**NEW YORK STATE THRUWAY AUTHORITY
DEPARTMENT OF ENGINEERING**

**AMENDMENT NO. 2
TO**

**CONTRACT TAB 24-13
D214968
PAVEMENT REHABILITATION AND
MISCELLANEOUS WORK FROM MILEPOST
(MP) 467.0 TO MP 485.5 WESTBOUND AND
MP 483.0 TO MP 467.0 EASTBOUND
IN THE BUFFALO DIVISION
IN CHAUTAUQUA COUNTY**

**IN THE LETTING OF
APRIL 17, 2024**

BRIDGE OVERPASS VERTICAL CLEARANCE
5" MILL & 5" OVERLAY TRANSITION
(EXISTING VERTICAL CLEARANCE MAINTAINED)
N.T.S.

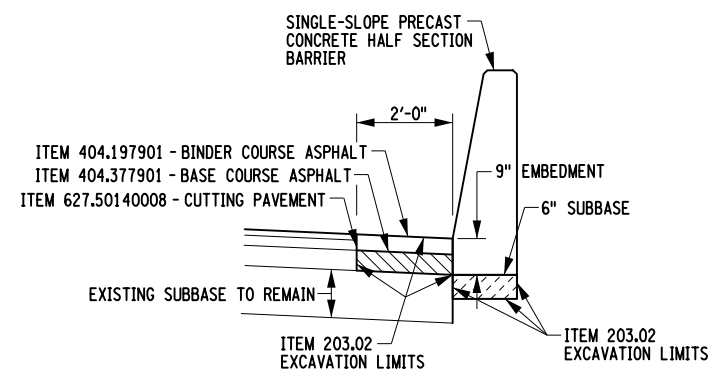
2. **DELETE** Drawing Number MSD-2, Sheet 22 of 126, and **SUBSTITUTE** with the attached Drawing Number MSD-2, Sheet 22-A2 of 126. The Single Slope Precast Concrete Half Section Barrier Typical Section (Prior to Milling & Overlaying Operation) detail and associated pay items have been added to the drawing. The Notes previously found on the upper right corner of the drawing have been renamed “Half Section Barrier Notes”, and a new Note 5 has been added. Similarly, the Notes previously adjacent to the Bridge Overpass Vertical Clearance detail has been renamed to “Vertical Clearance Notes”. These notes remain the same.

- VERTICAL CLEARANCE NOTES:**
1. MAINLINE TRAVEL LANES/SHOULDERS SHALL RECEIVE A 3" MILL & 4" OVERLAY PER THE GNP DWGS.
 2. EXISTING MAINLINE AT BRIDGE OVERPASS REHABILITATION LIMITS ARE APPROXIMATE BASED ON AS-BUILT INFORMATION. THE CONTRACTOR SHALL REHABILITATE A MINIMUM OF 100' ON EACH SIDE OF THE OVERPASS AND A SMOOTH TRANSITION SHALL BE PROVIDED TO AND FROM THE REHABILITATION SEGMENT PER NYSTA STANDARD SHEET, TA 402-03.
 3. BASED ON AS-BUILT INFORMATION THE MINIMUM VERTICAL CLEARANCE HAS BEEN ESTABLISHED. THE CONTRACTOR SHALL ACCOUNT FOR EXISTING CROSS-SLOPE AND/OR SUPERELEVATION WHEN TRANSITIONING FROM 3" MILL / 4" OVERLAY TO A 5" MILL / 5" OVERLAY SEGMENT TO MAINTAIN EXISTING MINIMUM VERTICAL CLEARANCE.
